Q42567

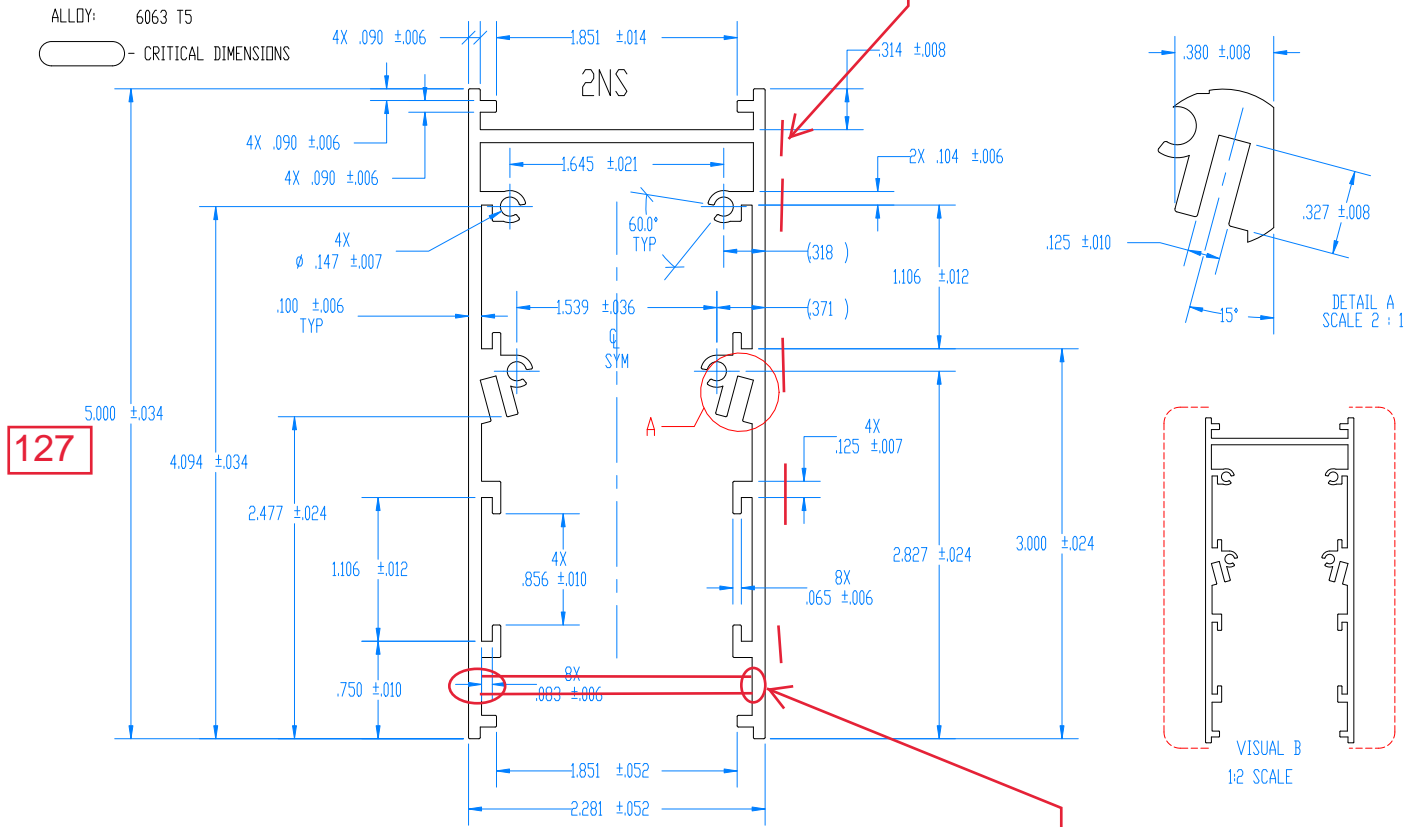
due to thickness variation we may get impression mark at these places

semi-hollow die a small projection mark may appear in these places
